Relicensing Study 3.1.2

NORTHFIELD MOUNTAIN/TURNERS FALLS OPERATIONS IMPACT ON EXISTING EROSION AND POTENTIAL BANK INSTABILITY

Initial Study Report Summary

Northfield Mountain Pumped Storage Project (No. 2485)
and Turners Falls Hydroelectric Project (No. 1889)

Service Layer Credits: Sources: Esri, DeLorme, NAVTEQ, USGS, Intermap, iPC, NRCAN, Esri Japan, METI, Esri China (Hong Kong), Esri (Thailand), TomTom, 2013
 Source: Esri, DigitalGlobe, GeoEye, i-cubed, USDA, USGS, AEX, Getmapping, Aerogrid, IGN, IGP, swisstopo, and the GIS User Community

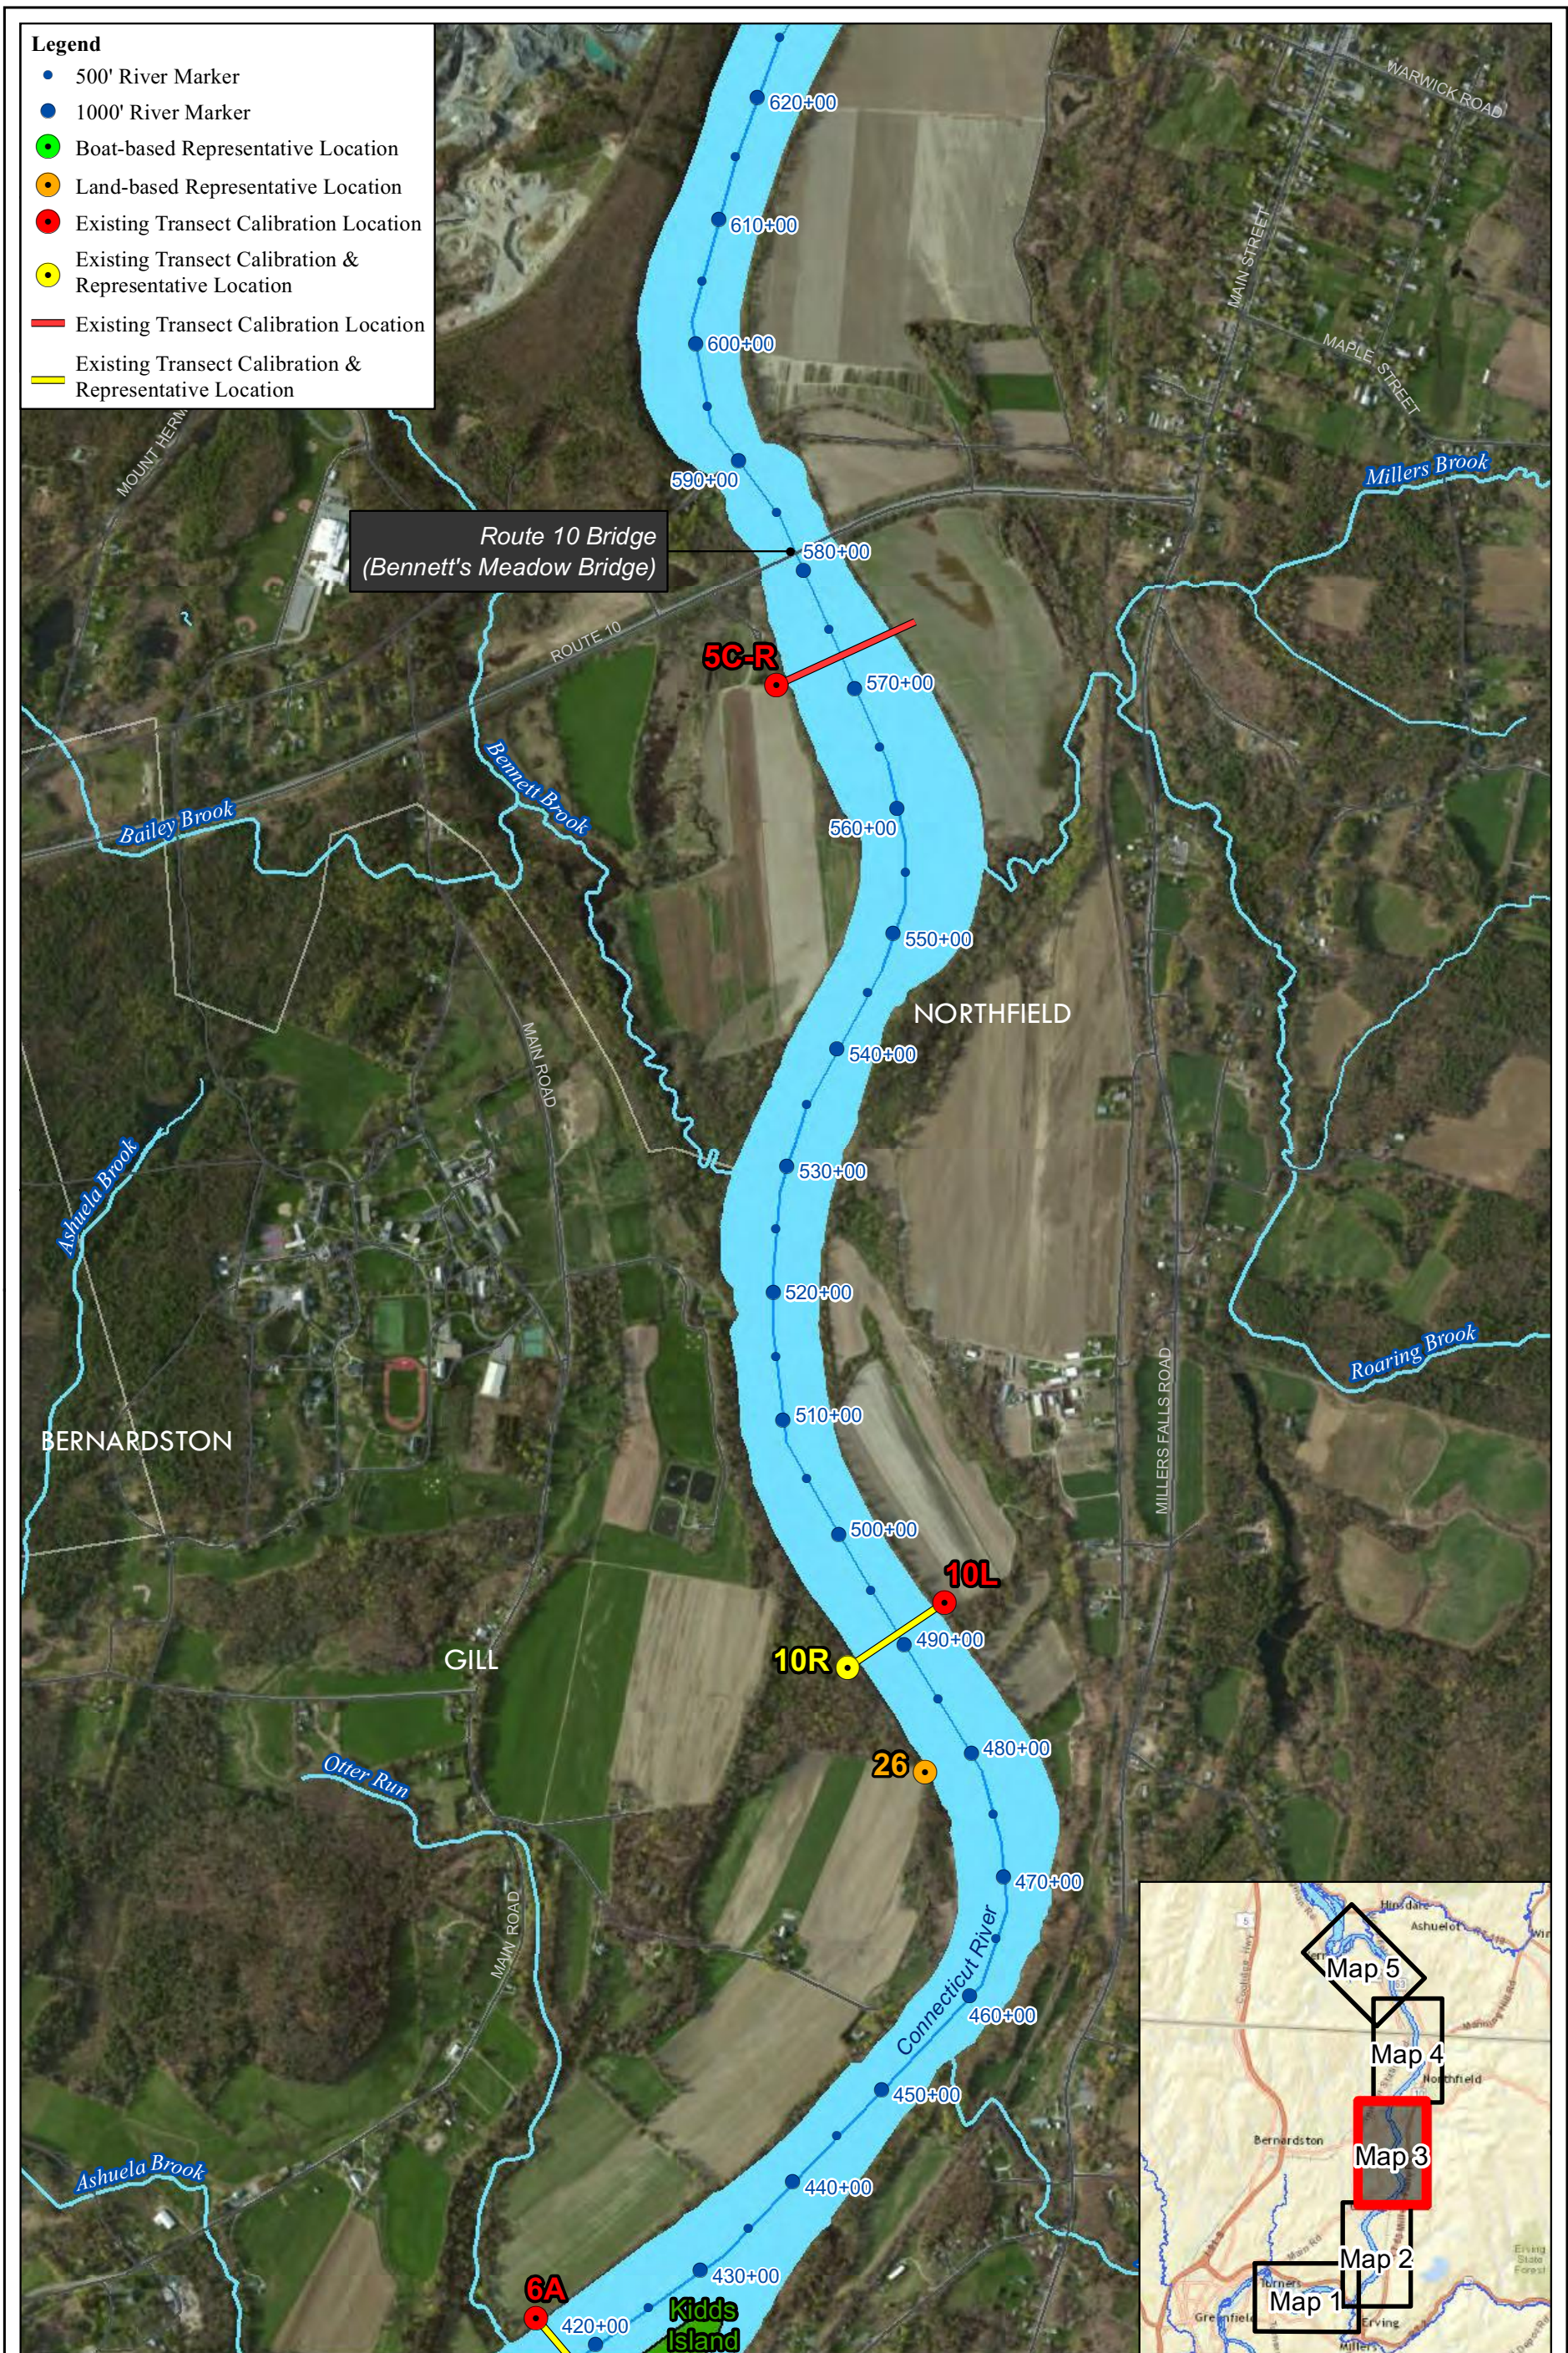
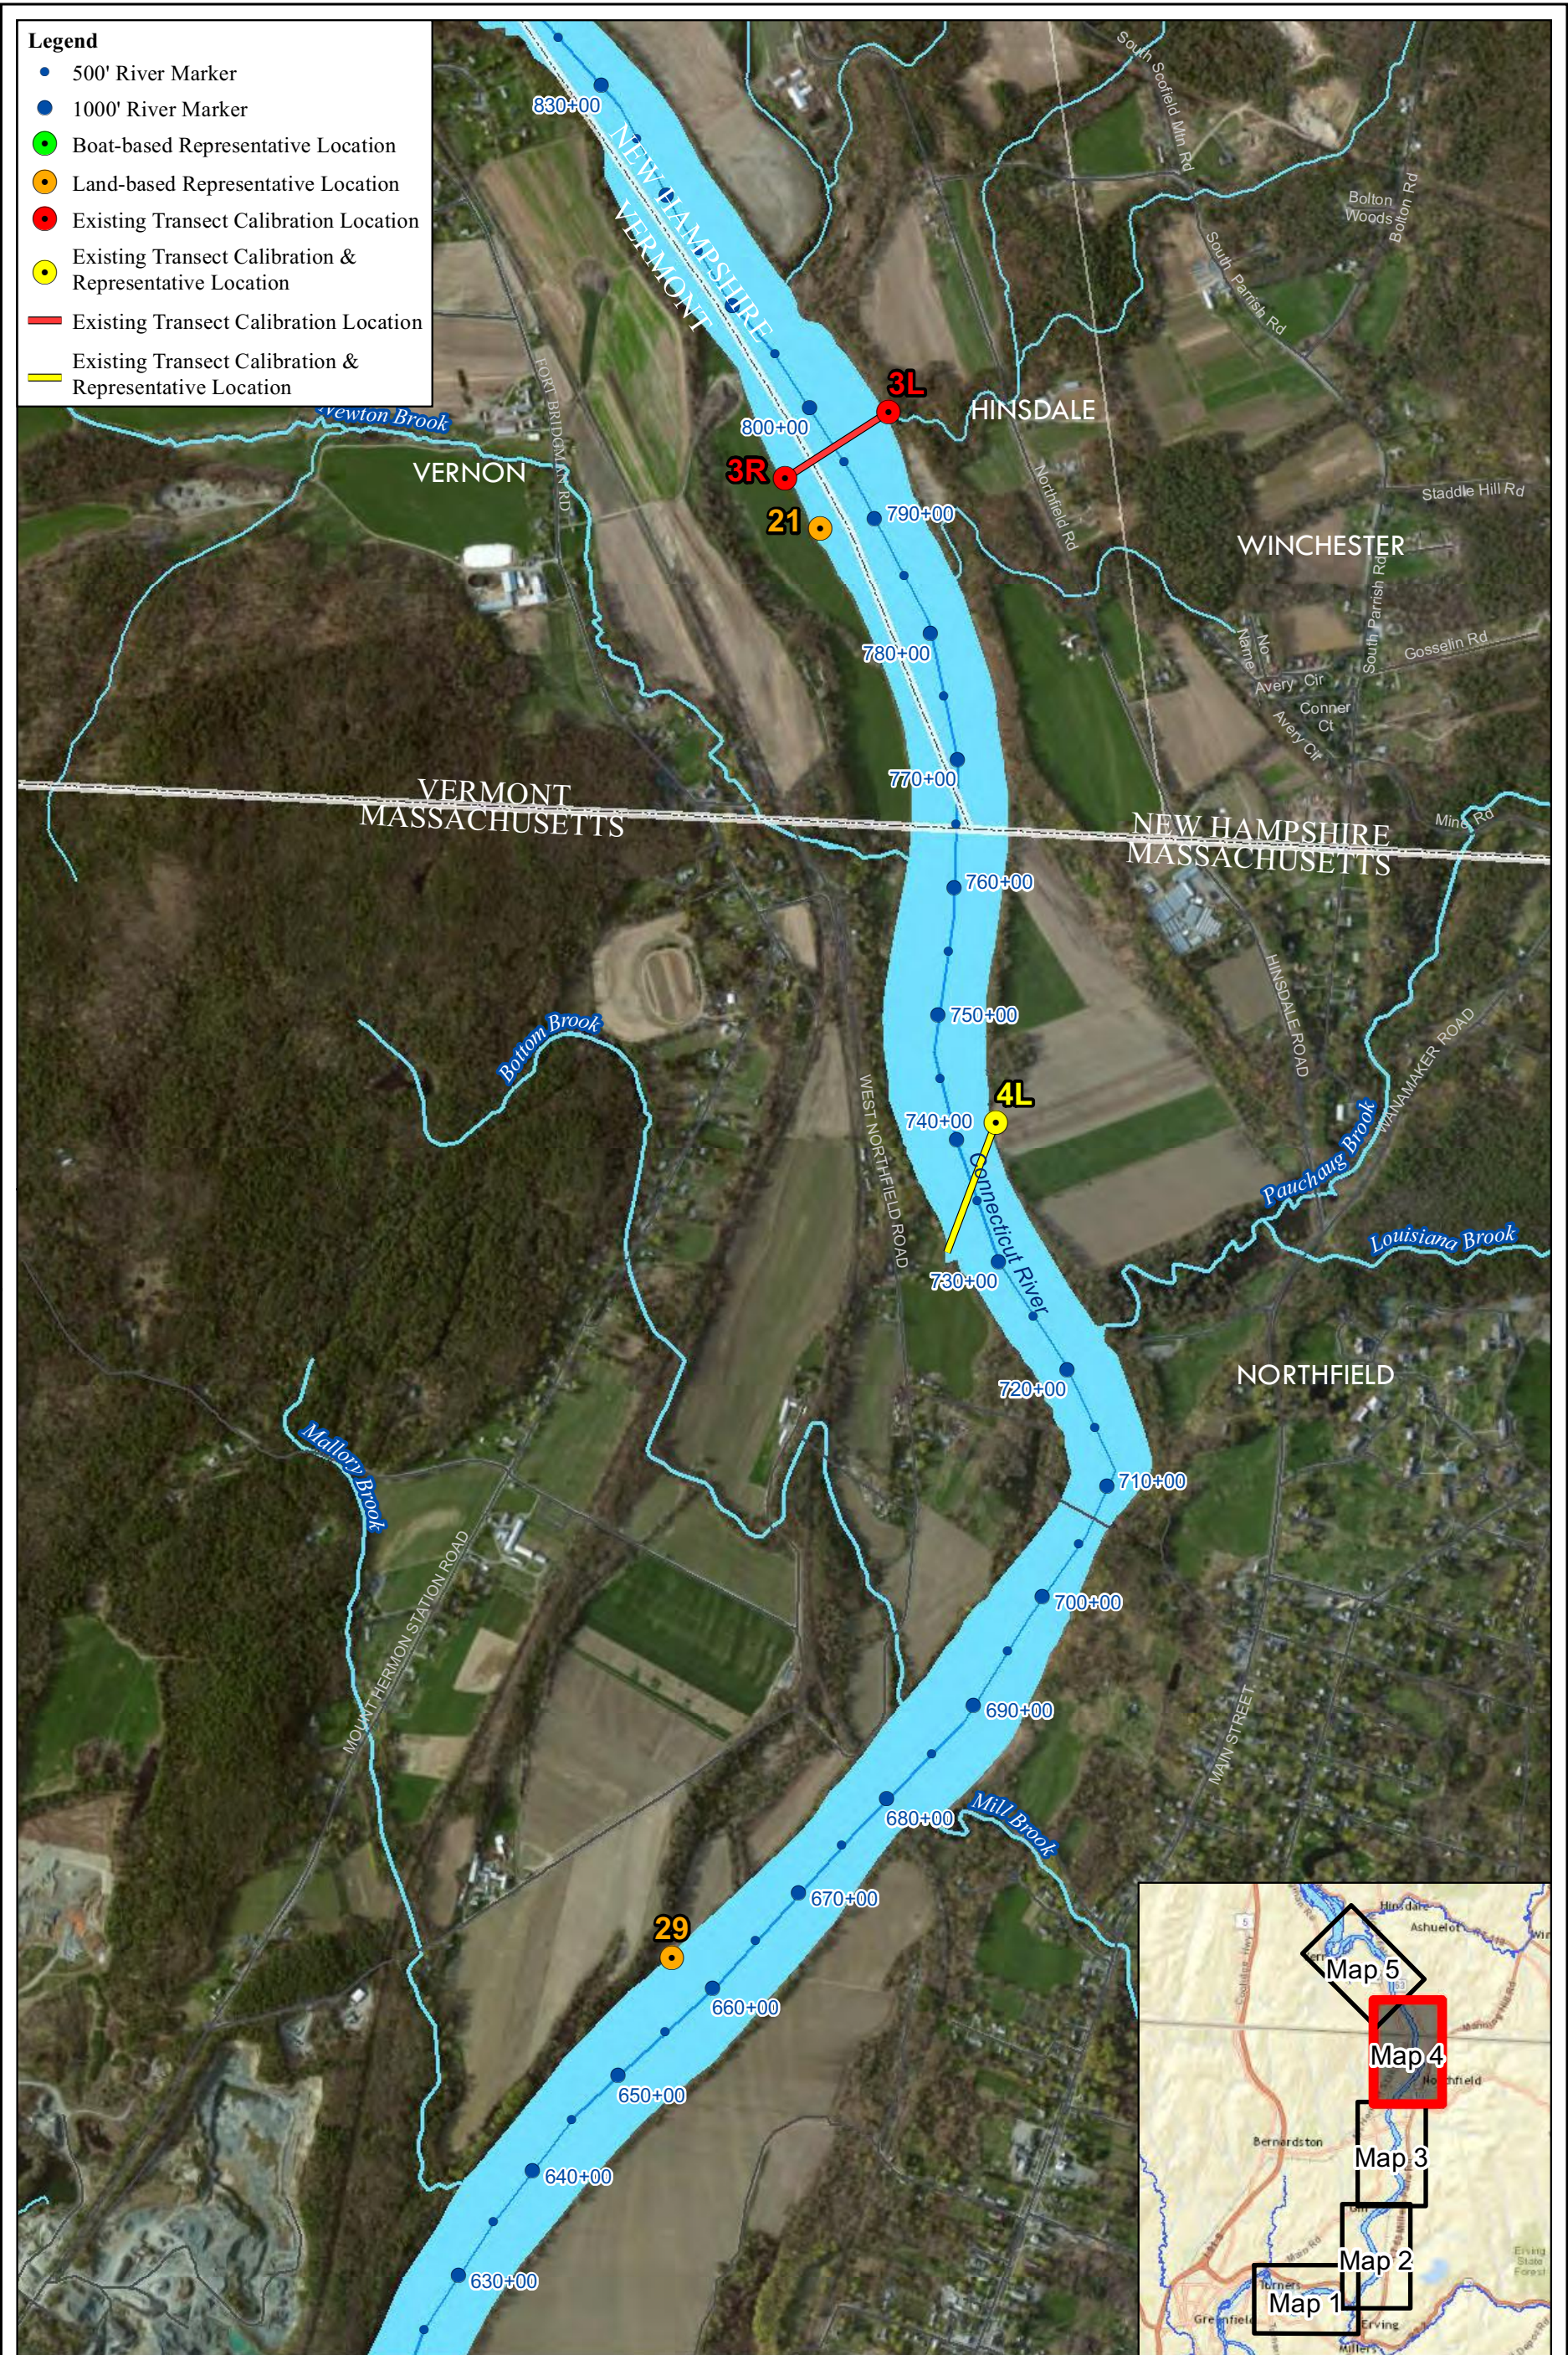
I categorized sites using the Proposed Representative & Calibration Locations for Detailed Study, Figures 7-2 through 7-6 plus one change as presented in Powerpoint at the June 26 meeting.

Comment: The stakeholders compiled a matrix of FirstLight's proposed representative and calibration sites and their locations at an Inside Bend, Outside Bend or Straight Reach. The distribution of these sites should be more even and gaps should be filled. There are plenty of Land-Based Survey locations that could be used to fill these gaps and even the distribution among the morphology types (see last table).

FirstLight has reviewed the letters received to date and has developed the enclosed responsiveness table and associated attachments in response to these comments. Stakeholders raised several concerns about the representativeness of the proposed sites. Concerns were specifically raised in regard to a lack of sites in the vicinity of the Northfield Mountain tailrace and in or near Barton Cove. To address these concerns FirstLight is recommending the addition of sites BC-1R and 87B as well as 303B. Site BC-1R is located on the peninsula entering Barton Cove while Site 87B is located just upstream of the Northfield Mountain tailrace. Site 303B is located downstream of the Ashuelot River confluence and satisfies specific riverbank characteristics requested by the Stakeholders. As explained in the attached documents these

sites will replace Sites 11I, 6A-I, and 90B. More information on this and other Stakeholder concerns can be found in the enclosed documents.
